HISTORIC AND DESIGN REVIEW COMMISSION

HDRC CASE NO: 2021-198

ADDRESS: 324 GARFIELD ST

TYPE OF WORK: Demolition of primary structure with new construction of a 3-story

Photographs

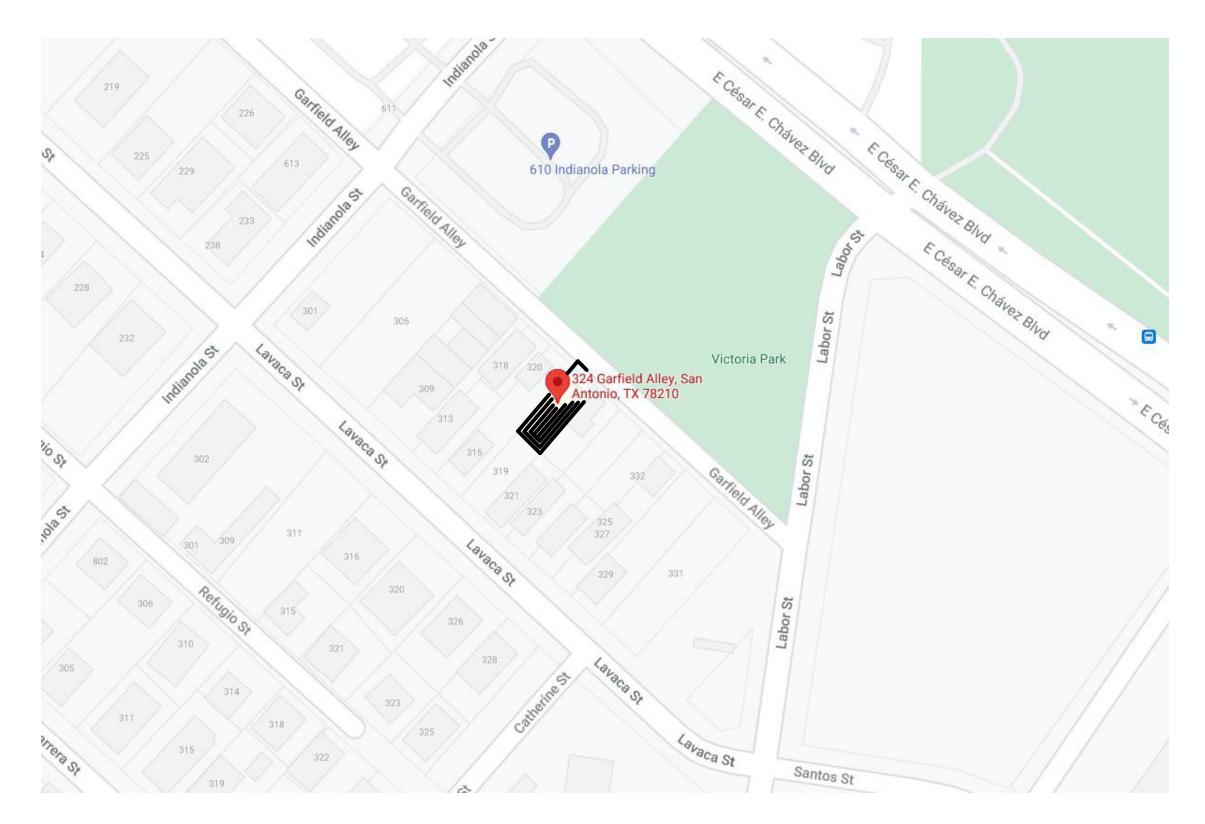
Entry door with gap due to failing structure

Gap in front wall with missing sill plate and termite damage on studs

SITE SECTION A

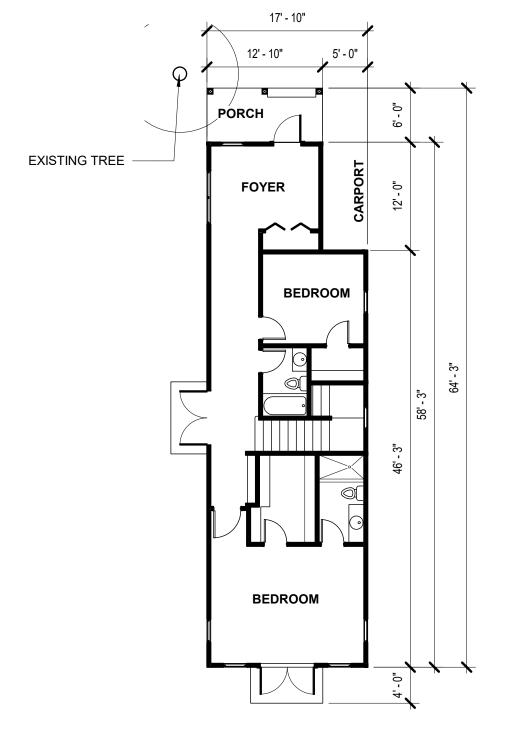
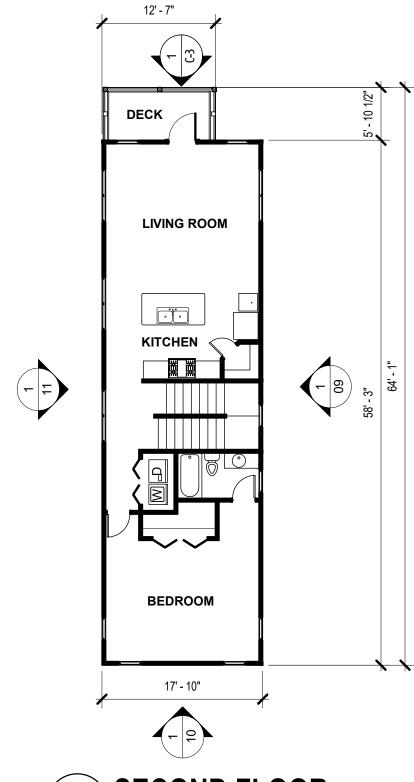
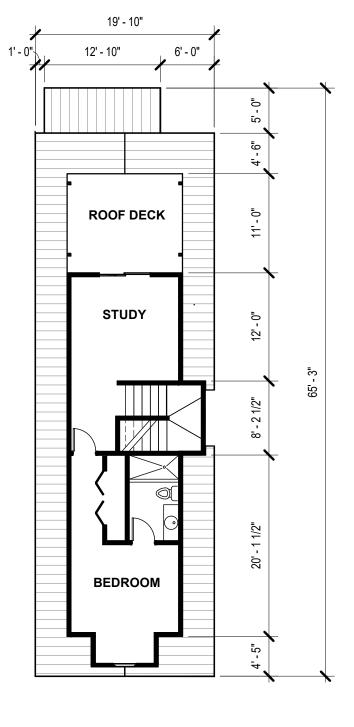
- 2d. SCALE & MASS Per the Guidelines for New Construction 2.A.i., a height and massing similar to historic structures in the vicinity of the proposed new construction should be used. The existing structure is 1-story in height. Most historic structures in the immediate vicinity on the block face feature either one or one and a half stories of height, with newer structures reaching two to two-and-a-half stories near major intersections, as well as on Lavaca St to the south of Garfield. The applicant has proposed a 3-story structure with a maximum height of 31'-6". According to the Guidelines, in residential districts, the height and scale of new construction should not exceed that of the majority of historic buildings by more than one-story. If there is no more than a 50% variation in the scale of buildings on the adjacent block faces, then the height of the new building shall not exceed the tallest building on the adjacent block face by more than 10%. The existing southern block face of Garfield features exclusively single-story structures. One structure, immediately adjacent to the lot to the east, features the tallest overall height on the block face, created by a 2-story rear addition. Staff finds that the proposed 3-story structure exceeds the majority of historic buildings by two stories, which is inconsistent with the Guidelines. Staff finds that a 1- or 2-story structure, or structure that increases in scale towards the rear of the lot, would be appropriate for the prevailing existing context of the site and immediate vicinity. Staff also finds that the applicant should submit a street elevation to place the proposed structure in context with historic structures on the block face.

- i. That the applicant aligns the front porch setback with the adjacent historic structures as noted in finding 2b.
- ii. That the applicant reduces the height to 2-stories to be more consistent with the prevailing scale of adjacent historic structures and the historic block face as noted in finding 2d.

- iii. That the explores ways to reduce the plate heights to further minimize the overall height of the structure wherever possible.
- iv. That the applicant submits a street elevation of the block to place the proposed structure in context with historic structures on the block face as noted in finding 2d.

EXTERIOR ELEVATION

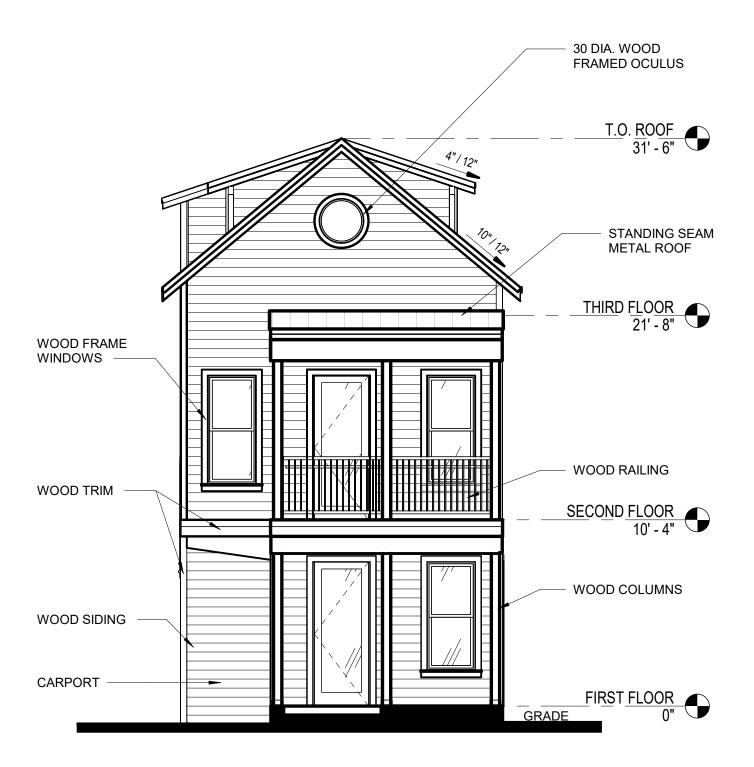
- 2f. ROOF FORM & PORCH According to the Historic Design Guidelines, roof forms that are consistent with those predominantly found on the block should be incorporated in terms of pitch, overhangs, and orientation. The applicant has proposed a primary gable roof form with a subordinate dormer roof detail to accommodate the interior stair and the third story. A portion of the roof will be a trellis that accommodates an outdoor porch. The front porch massing is proposed to be 2-story in height with a low-sloping shed roof and simple square columns. This porch form follows precedents in the district, however staff finds that the shed roof should be modified to feature traditional construction techniques that remove the thick fascia boards. Staff generally finds the primary gable form to be consistent with the block and area historic precedents, but finds that the applicant should further develop the roof form detailing to be more consistent with gable roofs in the district, including the

- 2g. WINDOW & DOOR OPENINGS Per the Guidelines for New Construction 2.C.i., window and door openings with similar proportions of wall to window space as typical with nearby historic facades should be incorporated into new construction. The applicant has proposed a fenestration pattern with several paired windows and single windows that feature a one over one configuration and trim detailing, proportions, and inset that generally appear consistent with historic precedents. Staff finds that the paired windows should be designed to feature a true ganged condition. The windows should be consistent with staff's standard window stipulations as listed in the recommendation.

- v. That the applicant further develops the gable roof form and detailing to be more consistent with historic precedents in the district as noted in finding 2f.

- vi. That the applicant modifies the proposed porch design and shed roof detailing to reduce the fascia height and visual bulk of the support elements as noted in finding 2f.

- vii. That the windows feature a true ganged condition. All windows must be fully wood or aluminum clad wood and feature a one over one configuration. Meeting rails must be no taller than 1.25" and stiles no wider than 2.25". There should be a minimum of two inches in depth between the front face of the window trim and the front face of the top window sash. This must be accomplished by recessing the window sufficiently within the opening or with the installation of additional window trim to add thickness. Window trim must feature traditional dimensions and an architecturally appropriate sill detail. Window track components must be painted to match the window trim or concealed by a wood window screen set within the opening.
